To: DW® employees
 Date: September 15, 2021
 Re: DWC-PMB-WLW universal pole mount update

DWC-PMB-WLW universal pole mount update

Pole mount front view

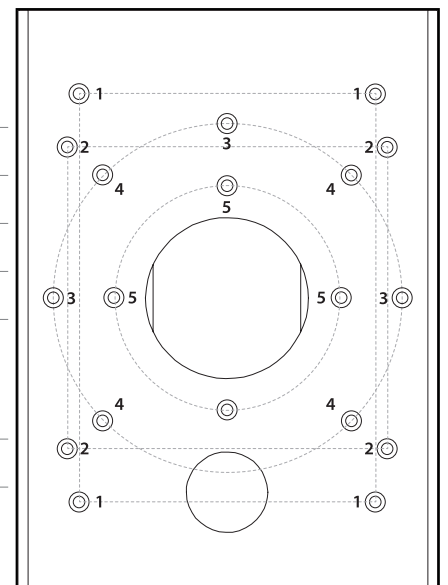
The optimized universal DWC-PMB-WLW hardware now supports multiple products and will replace all other current pole mounts. The new hardware will include numbered mounting points, each number compatible with different wall mounts and junction boxes. Refer to the table below for supported products.
